MEMORANDUM FOR: FILE

SUBJECT: No Additional ESA or EFH Consultation Needed for Design Refinements
to the Big Island Living Shoreline Component, Phase IV Early
Restoration, Mississippi

Big Island Living Shoreline Component

June 26, 2019

Figure 1: Conceptual project design proposed in the 2015 Final Biological Evaluation, Proposed Big Island Living Shoreline

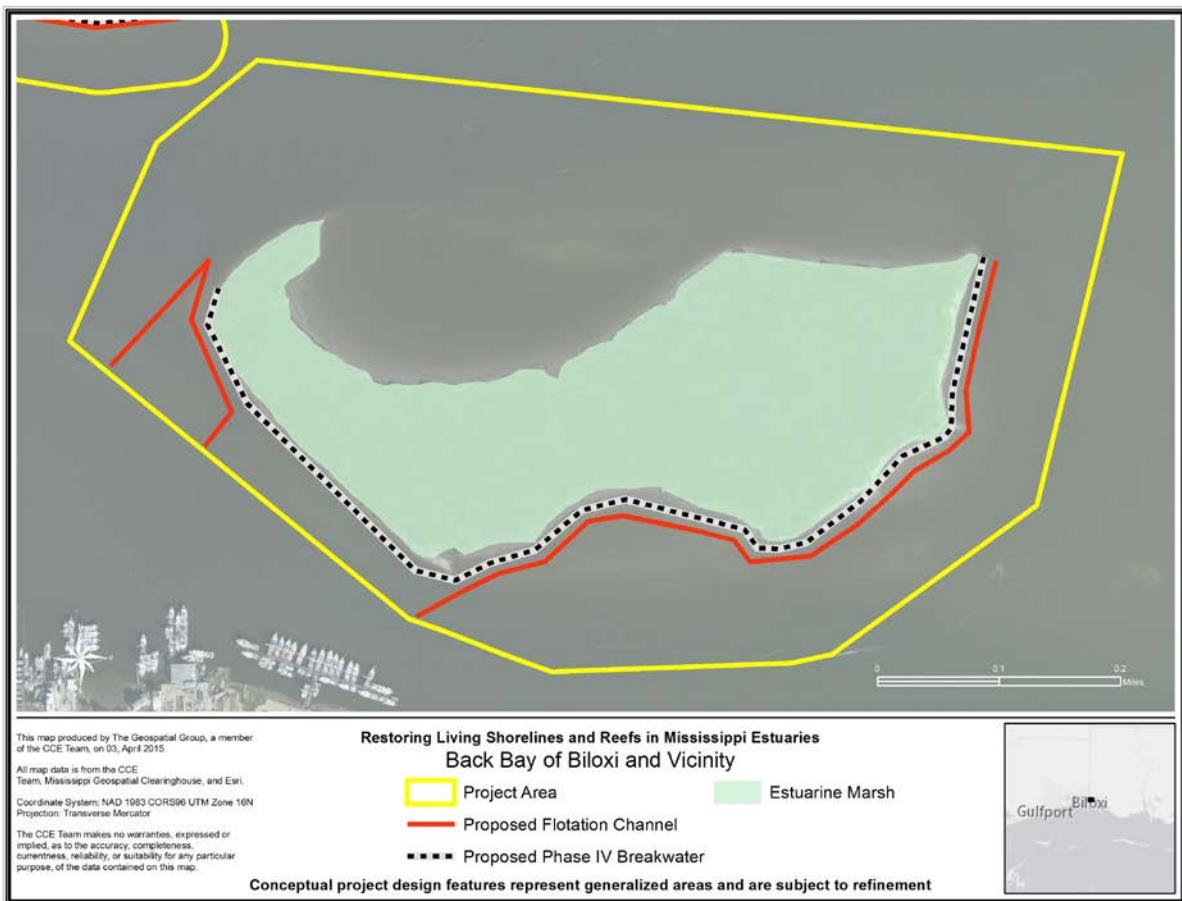
construction of two breakwaters instead of one: an outer breakwater constructed of riprap with crest elevation at mean higher high water to reduce wave energy, and an inner breakwater constructed of riprap, Wave Attenuation Devices (WADs), OysterBreaks or other comparable engineered structures/materials as approved by the permitting agencies, with a crest elevation at mean lower low water to provide additional wave attenuation and to maximize secondary productivity benefits. Please note that the latest design does not affect the total project footprint (3.5 acres) or the project location, and has eliminated the flotation channels originally proposed in the 2015 consultation.

Figure 7: Current Design Big Island Living Shoreline (Inner breakwater WAD option) in Profile View

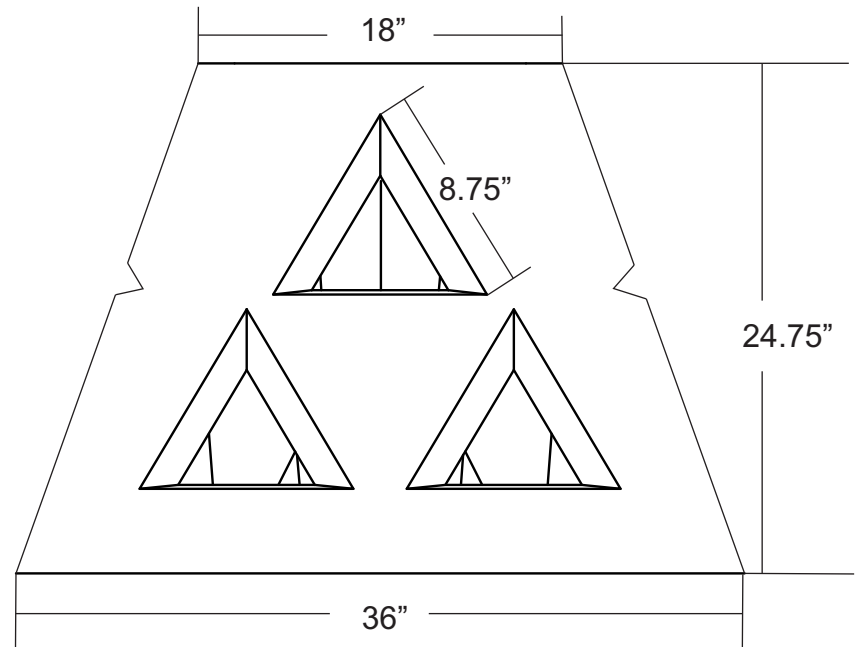
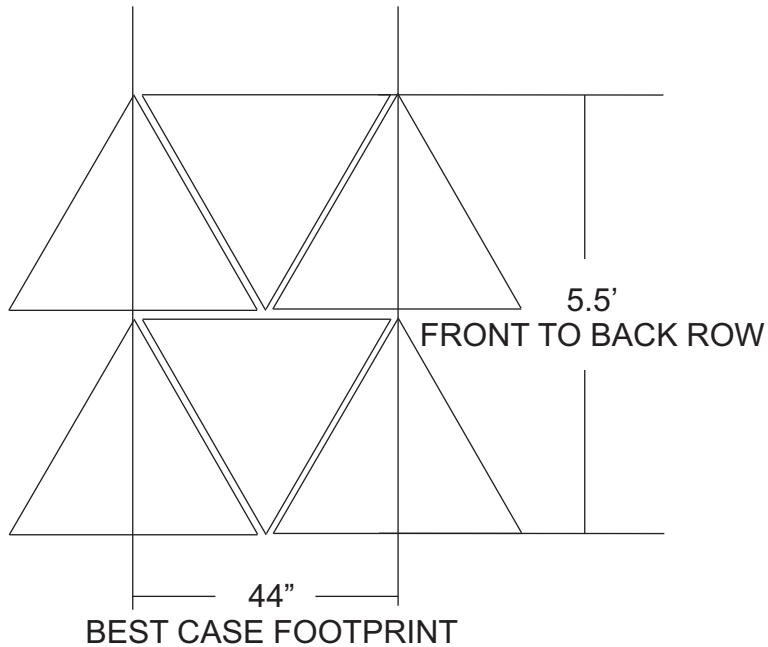
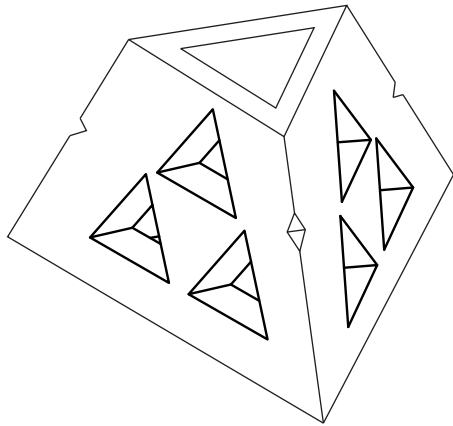
The inner breakwater is likely to be built with a pre-fabricated wave attenuation device. While the device has openings on the side, it also has a sufficient opening on the top and therefore is not likely to entrap any protected species (see attachment for drawings).

Based on my review of project materials including design updates (see attached) and in coordination with representatives from NOAA's Protected Resource Division and Habitat Conservation Division in the South East Regional Office, the NOAA Restoration Center determined that design updates do not require re-initiation of consultation with NOAA.
